Assessment of Contributions Plan No.18 –
Bella Vista and Kellyville Station Precincts:
Technical Paper

Final Report

February 2022

Figure 7.1 Assumed residential development path for CP18

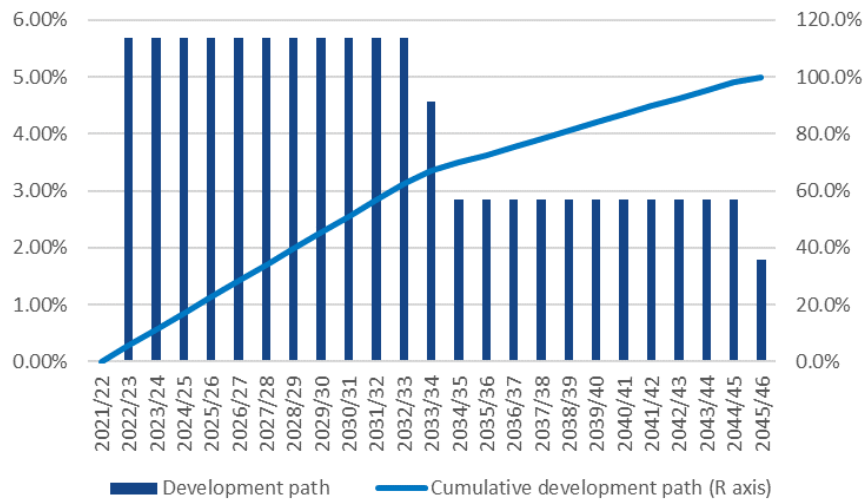
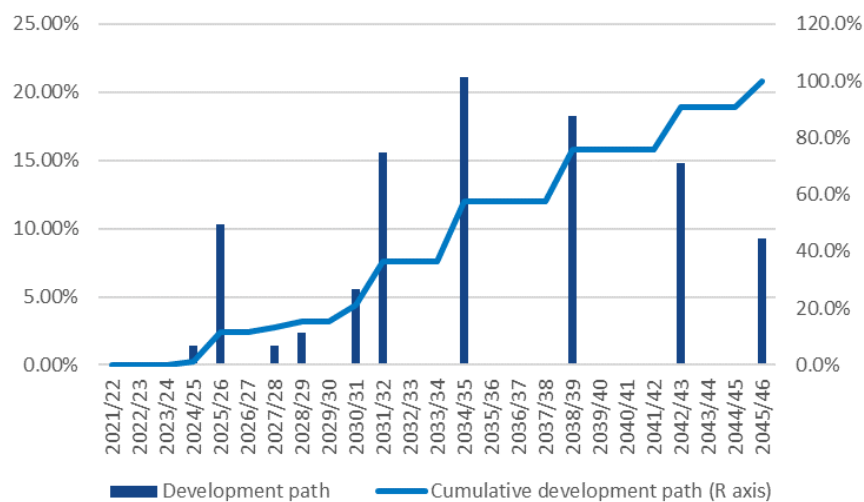
The most recent development paths provided are presented in Figure 7.1 and Figure 7.2 below. These show that while residential development is expected to occur each year, non-residential development will occur in stages, with most occurring in the second half of the plan. We consider that these development paths are reasonable, and recommend that the Council update its NPV models to reflect the revised development paths.

- 13. Update the development paths in the residential and non-residential NPV models, and in Table 1 of CP18, to reflect post-exhibition dwelling and yield amendments.
